Certificate of Appropriateness

2804-2810 W. KILBOURN AV. Concordia Historic District

Description of work Applicant proposes to repair damaged brick wall at rear of this apartment building. Damage

PTS ID 102994 COA

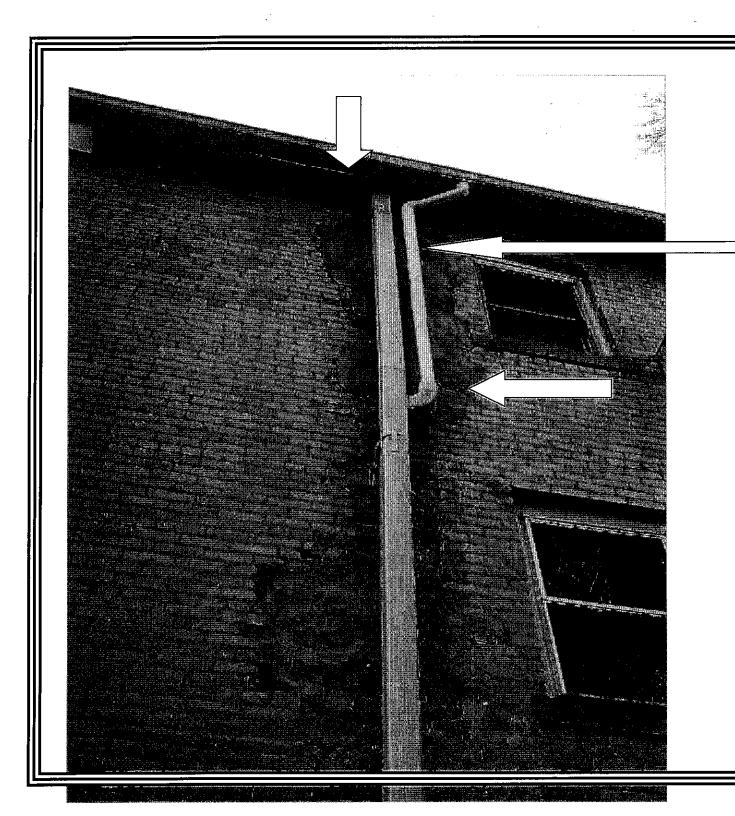
Downspouts to be replaced and properly connected to receiver and gutter system.

Deteriorated brick to be removed and new brick patched in. New brick to match existing in size and shape. Mortar to match existing in hardness and color and pointing style.

Plaster patch over brick will be removed.

Soffit area to be repaired.
